Mr. Dwight Russell, P.E.
Municipal Solid Waste Permits Section – MC 124
Texas Commission on Environmental Quality
12100 Park 35 Circle; Bldg. F
Austin, Texas 78753

Re: Pescadito Environmental Resource Center - Webb County
Municipal Solid Waste (MSW) Permit Application No. 2374
Notice of Deficiency - Technically Complete Permit Application Supplement Number 5
Tracking No. 21876231; CN603835489/RN106119639

APTIM Environmental and Infrastructure, Inc. is in receipt of your letter dated October 23, 2017 in which you are asking for additional information and clarification related to our submittal of August 17, 2017.

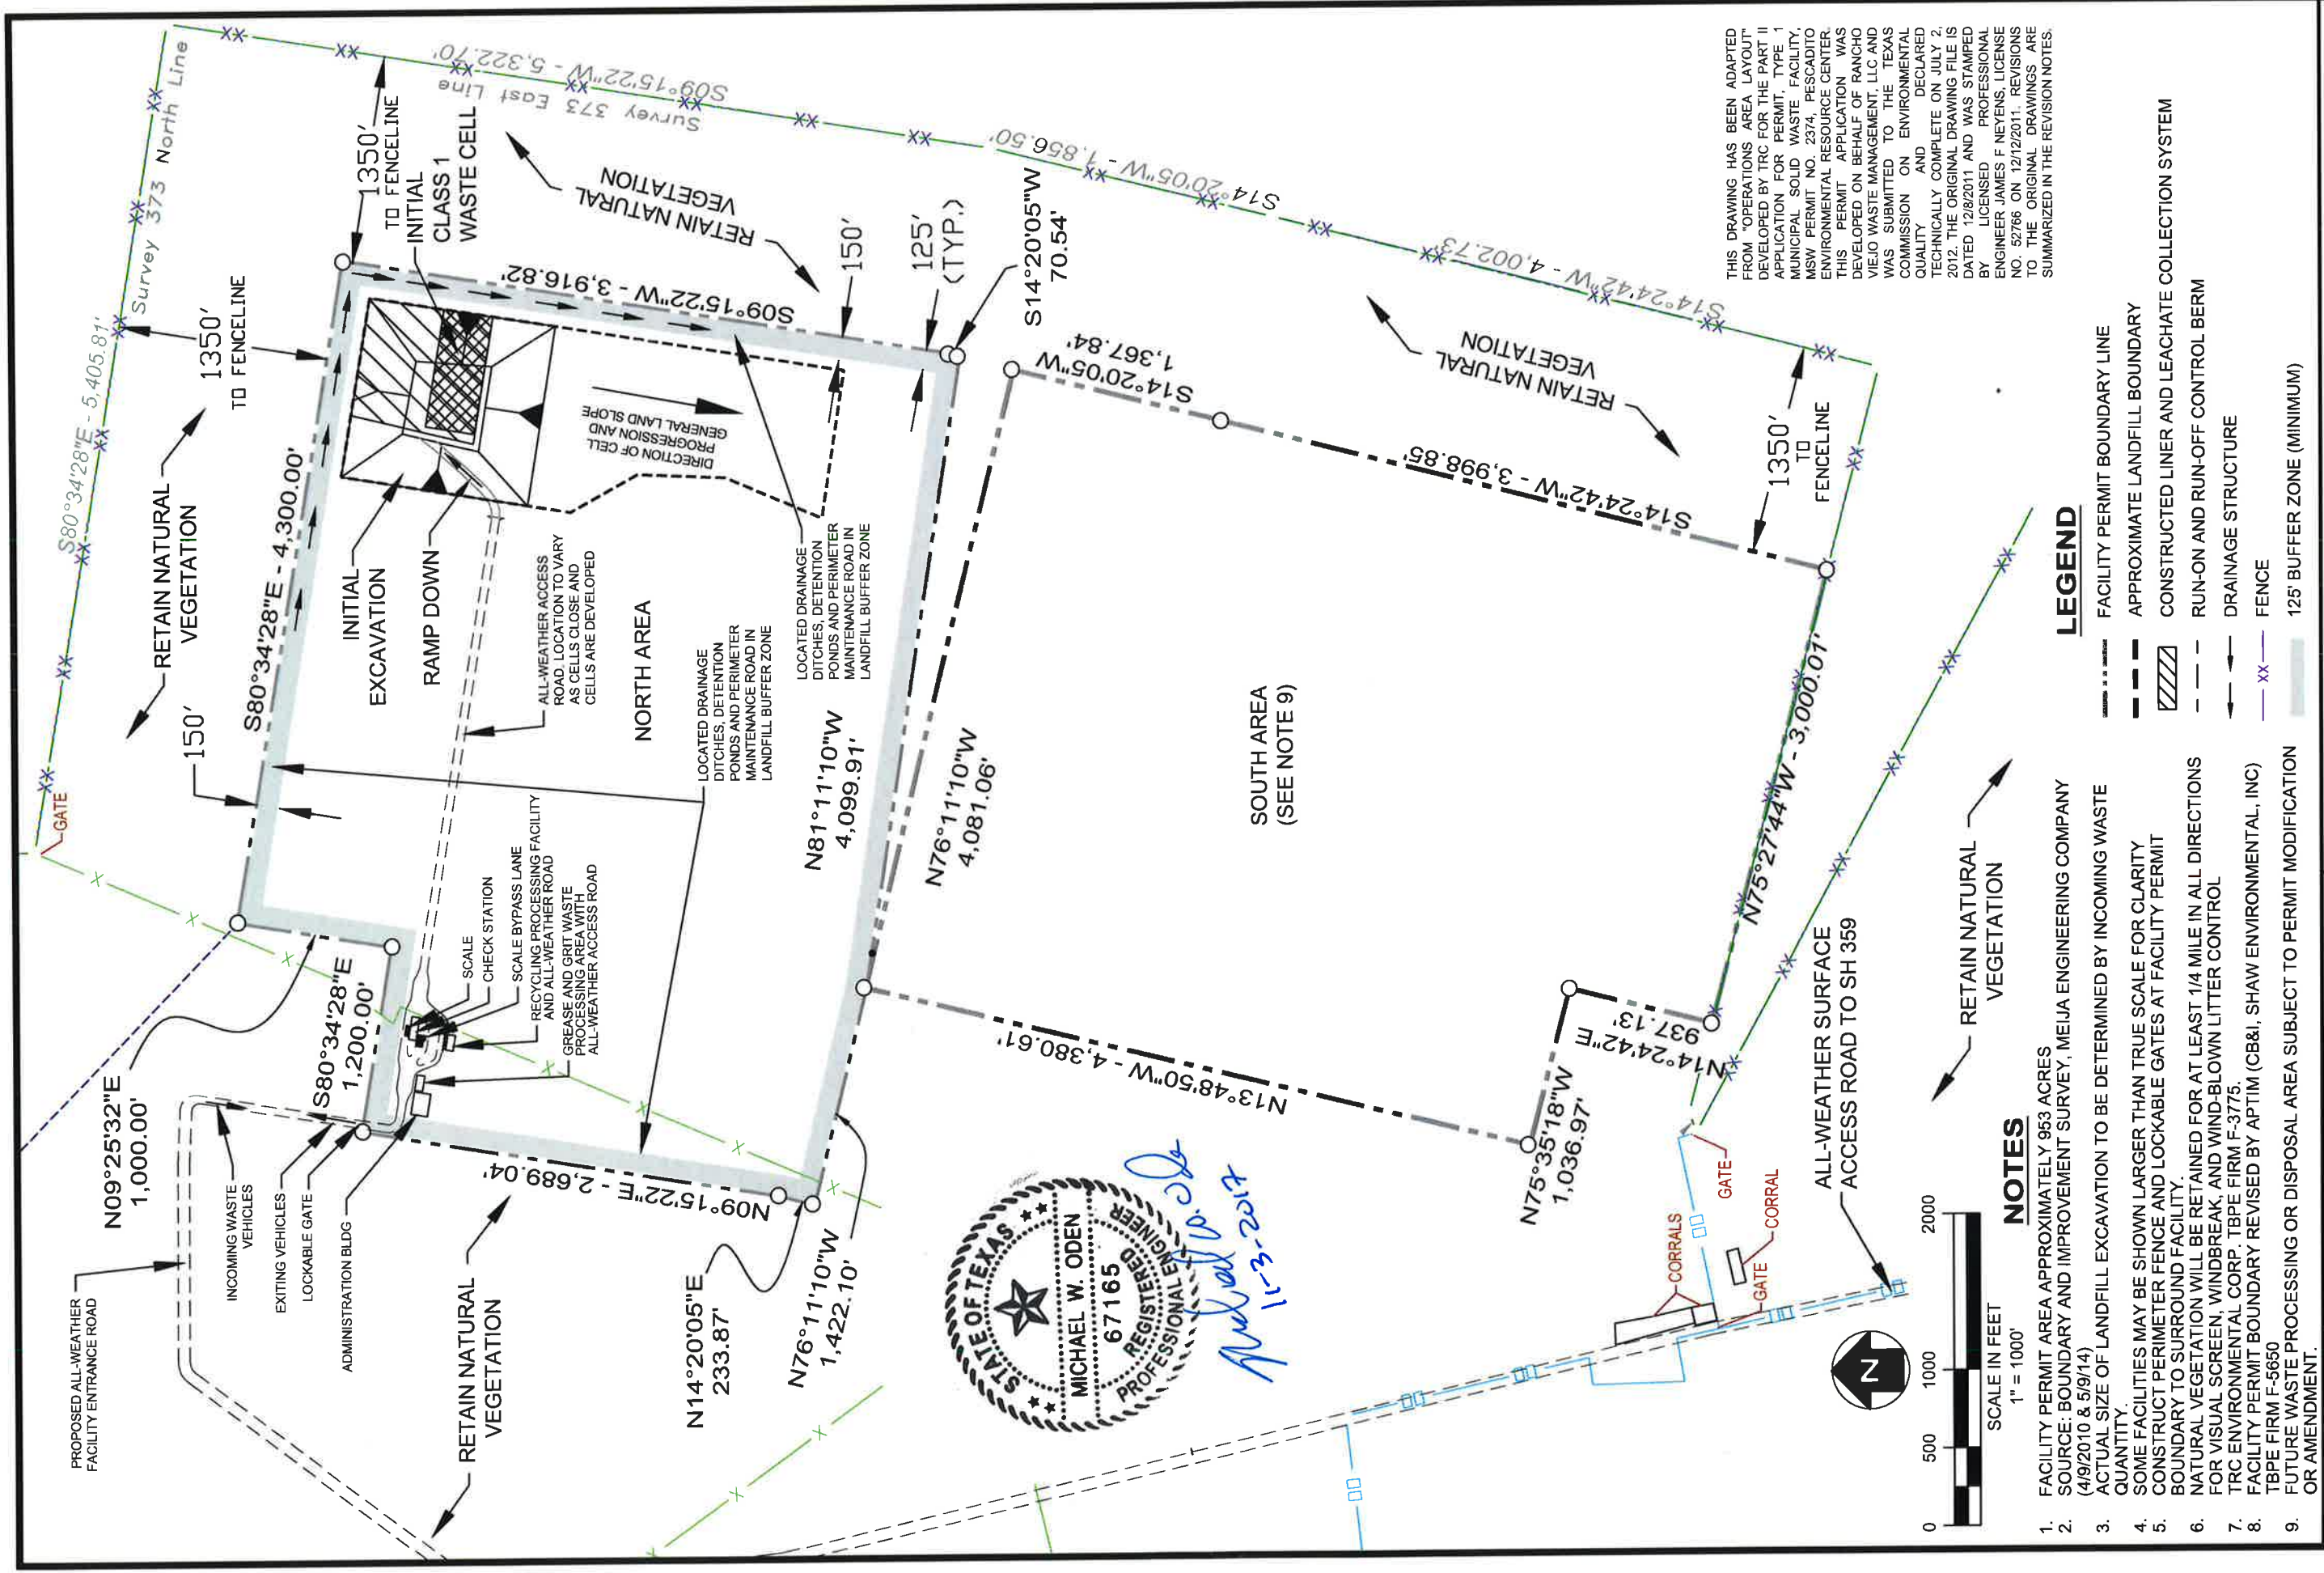
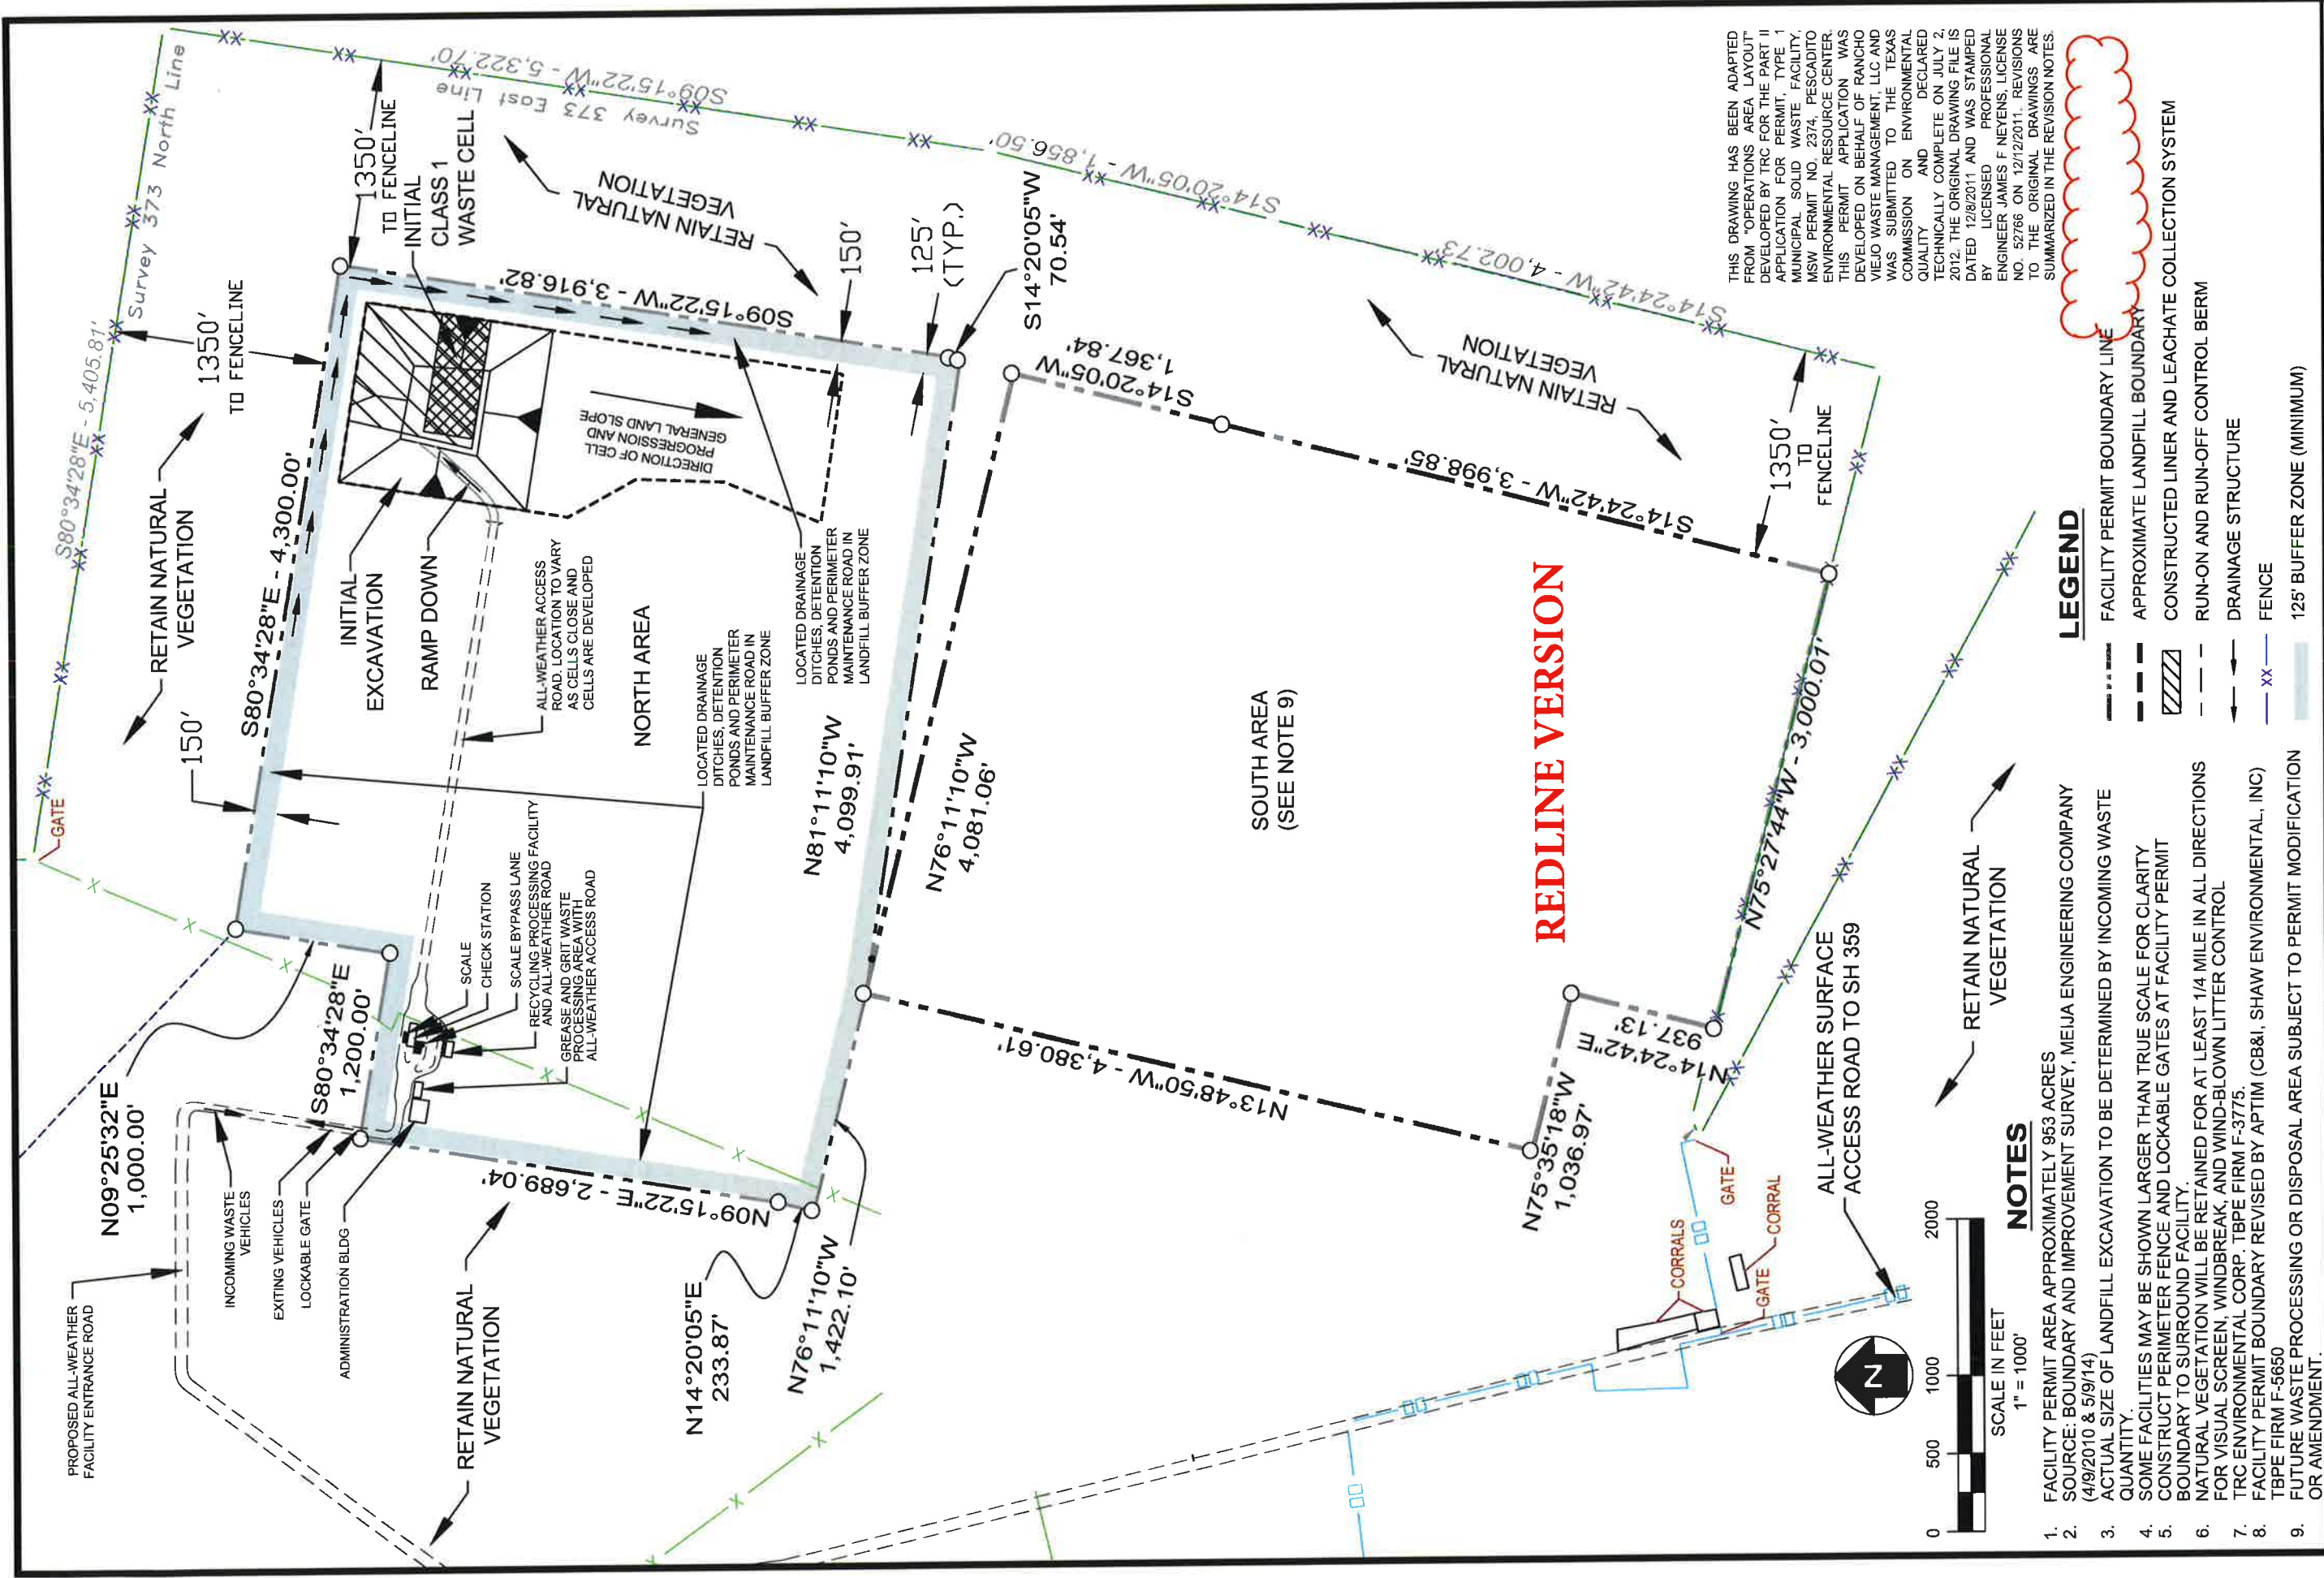
- 2) Part II, Figure 4 shows a fence running north/south just east of the gate house/scale area. This fence intersects the buffer zone and there is no perimeter fence tied into the entrance road gate. Please revise Figure 4 to clearly show all fencing and gates that are to provide security per §330.131 and comply with §330.141(b) regarding safe passage for emergency vehicle traffic.

Part II, Figure 4 is not intended to show the site access control features. Access control features are discussed in Part III, Attachment III-B on Page 1 and are shown on Drawing III-B.1-2 in Part III, Appendix III-B.1. That figure has been updated as requested. Additionally, the text in Part II has been modified to

reference the correct drawing and Part II, Figure 4 has been revised to delete the reference to Access Control Fence in the legend.
